Technical Service Bulletin

**SCBS / SBS, LAS / LDWS, MASTER AND/OR HBC WARNING LIGHTS
ON WITH DTC U3000:98 STORED DURING HOT WEATHER**

Bulletin No.: 15-002/18

Last Issued: 12/05/2018

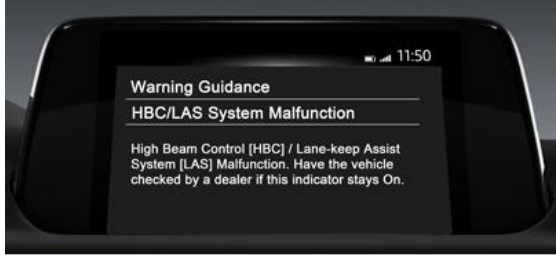
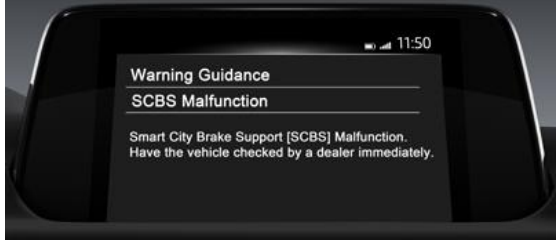
[Earlier production Mazda3, Mazda6, CX-3 and CX-5 until summer 2017] The warning lights may stay on and these functions are deactivated until the ignition switch is turned off. Both U3000:98 (FSC) and U3000:04 (FSC) are stored.

This condition may be caused by FSC control logic that is too sensitive. When the FSC detects DTC U3000:98 during high temperature, it stops the internal communication and stores DTC U3000:04. DTC U3000:04 will not clear and SCBS/SBS, LAS/LDWS, and/or HBC functions will not resume until the ignition switch has been turned OFF even if the temperature of the FSC cools.

This condition may be caused by **poor heat radiation performance of the FSC. To eliminate this concern, a thermal pad has been added to the FSC.**
